**RE: PA22-044 – Olympic Vista PRD – Technical Review 2**

Please refer to our responses below which address all review comments received from the City of Marysville on May 16th, 2023, regarding the Olympic Vista PRD proposal resubmittal. You will find the markup comments listed in the order that they were written followed by our response in *italics*.

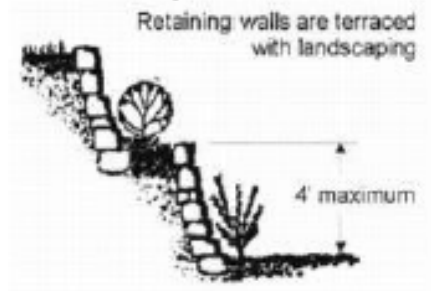
1. Pursuant to MMC 22D.050.030(4)(e), retaining walls taller than four feet and are visible from the street **or adjacent property** shall be terraced so that no individual segment is taller than four feet. This is anticipated to be a condition of preliminary approval. Compliance will be verified during civil construction plan review.

**Tall retaining walls must be terraced with landscaping as depicted below.**

***Response: The walls along the north property line that are greater than 4 feet are cut walls, so they will not be visible from the adjacent, offsite parcels. There are no fill walls along the south property line that are greater than 4 feet tall – see sheet GR-01 to confirm.***
